Memorandum

Subject: Palen Solar Power Project (09-AFC-7) Energy Commission Staff Rebuttal
Testimony

In its October 6, 2010 Opening Testimony, the applicant questioned the necessity of Trans-6 to control glint or glare from the project. Staff here provides additional testimony explaining the need for this measure and proffers some changes to the condition designed to address the applicant's previously stated concerns about operational restrictions. Additionally, in the area of Cultural Resources staff has identified a need to update Conditions of Certification 11, 12, 13, and 14 to include reference to those sites that would be encountered under the project configuration of Alternative 2 or 3.

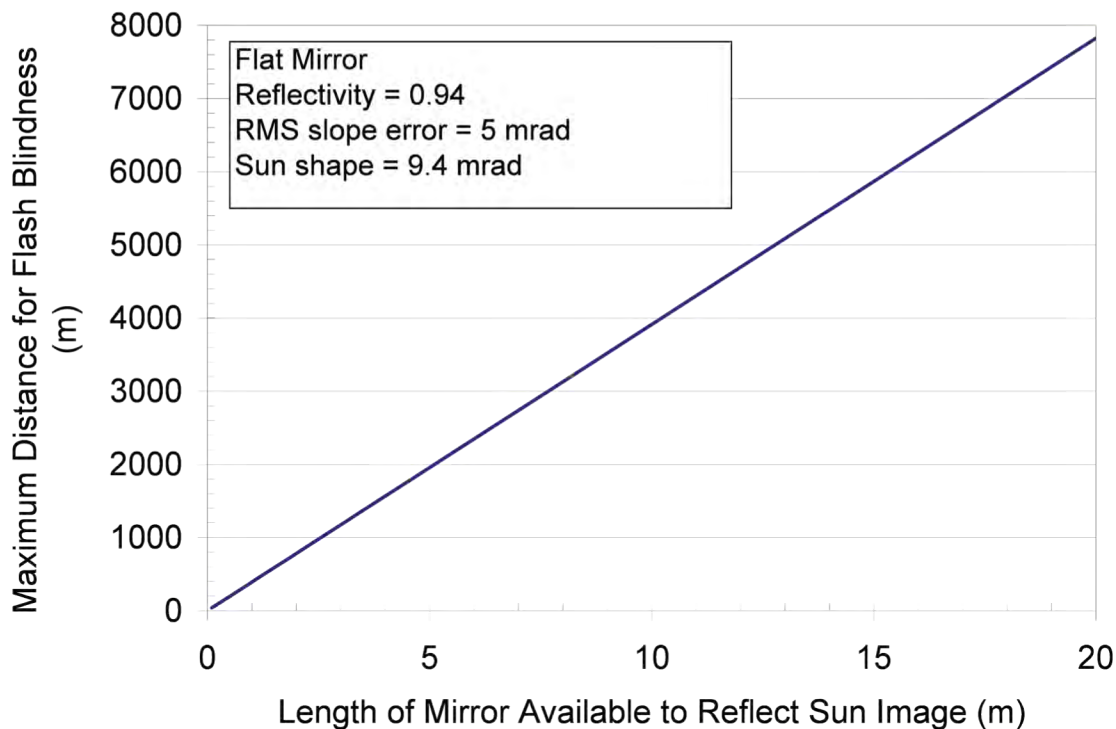
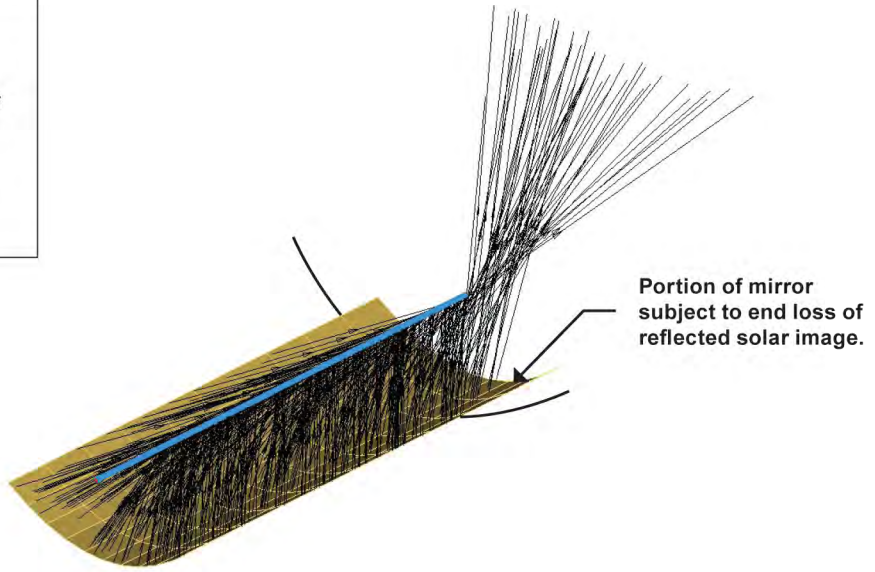
Figure **Glare 1** was developed for this study to provide criteria for assessing the potential impacts of intrusive light from the proposed PSPP facility. The figure presents maximum distances between the parabolic mirror and an observer at which flash blindness can occur as a function of mirror length available to reflect the sun. (Permanent eye damage is not a concern at the distances from the parabolic troughs for off-site observers.) The calculated distances assume specular reflection from a mirror with a reflectivity of 0.94, a subtended sun angle of 9.4 milliradians (mrad), and an RMS slope error of 5 mrad.⁵² The focal length for the collector is assumed to be infinite, which would be true of a flat mirror. This validly represents the nature of the reflection off the long (linear) axis of the trough collector. The reflected sun image along this long axis, rather than the short parabolic axis, is the critical feature in assessing the potential for flash blindness. The reflected image of the sun along the long axis would maintain a constant subtended angle in the observer's visual field as the observer moves further from the mirror. This effect would continue until the observer is so far from the mirror that the entire image of the sun overfills the available mirror area, at which point the subtended angle of the reflected sunlight would decrease with increasing distance.

Figure **Glare 1** indicates that the maximum distance that can cause flash blindness depends on the length of the mirror available to reflect the sun (which dictates the subtended angle of the reflected sun image as a function of distance). The longer the mirror, the greater the distance capable of causing flash blindness. A flat mirror 5 meters in length would reflect sunlight intense enough to cause temporary flash blindness approximately 2,000 meters away. A flat mirror 20 meters in length would reflect sunlight that could cause temporary flash blindness a distance of 7,800 meters (approximately 4.8 miles).

Glare 2

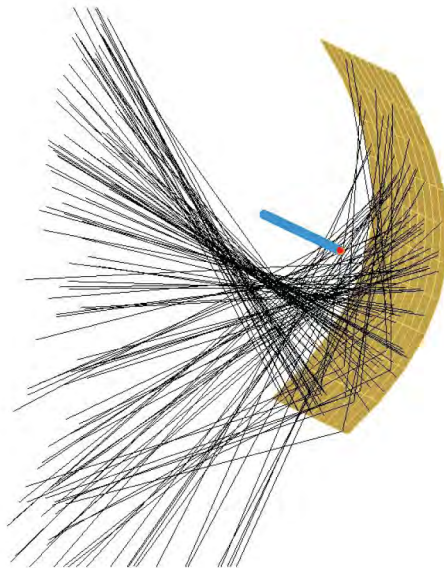
Figure **Glare 2** illustrates the situations during which specular reflections from the mirror arrays would extend off the PSPP plant property. The top panel is a

schematic representation of end loss or spillage of the reflected solar image off the end of the parabolic mirror. This would occur when the sun is low on the horizon – during the middle of the winter, early on summer mornings, and late on summer evenings. At the proposed PSPP site, the sun is approximately 33 degrees above the horizon on noon of the winter solstice.⁵³ When the sun is 33 degrees above the horizon, and assuming that the heat collection element is 1.5 meters from the vertex of the parabolic mirror, approximately 2.3 meters at the northern edge of the mirrors would spill specular reflections of the sun off the north edge of the mirror array. Referring to Figure **Glare 1**, a flat mirror 2.3 meters in length would reflect sunlight intense enough to cause flash blindness a distance of approximately 900 meters (2,950 feet). The bottom panel on Figure **Glare 2** indicates how sunlight would be reflected if the mirror array was misaligned or moving to or from the stow position. In those situations, the entire length of the mirror would be available to create specular reflections. According to information provided by the applicant, each mirror unit is 63 feet (approximately 19 meters) long.⁵⁴ These units are arranged end-to-end in rows 1,200 to 1,300 feet (approximately 400 meters) long. If one of the 19-meter long mirror units was misaligned with the sun, it would reflect intrusive light capable of causing temporary flash blindness at a distance of about 7,600 meters (approximately 4.7 statute miles). If an entire row of mirrors was misaligned, it could reflect blinding intrusive light capable of causing temporary flash blindness considerably farther, potentially dozens of miles.⁵⁵

Potential for end loss when sun is low on the horizon to the northeast, south, or northwest of the mirror array.

Potential for reflection along length of mirror array when misaligned with sun or when moving to or from stow position.

TRANS-6 To reduce glint and glare from the Project, the Project Owner shall implement the following measures during operation of any unit:

1. Ensure the mirrors are brought out of stowage before sunrise and are aligned to catch the first rays of the morning sun;
2. Ensure the mirrors are returned to stow position after sunset;

3. As soon as is feasible, redirect malfunctioning mirrors to the east in a manner so that there is no reflection from the sun as the sun continues west; and
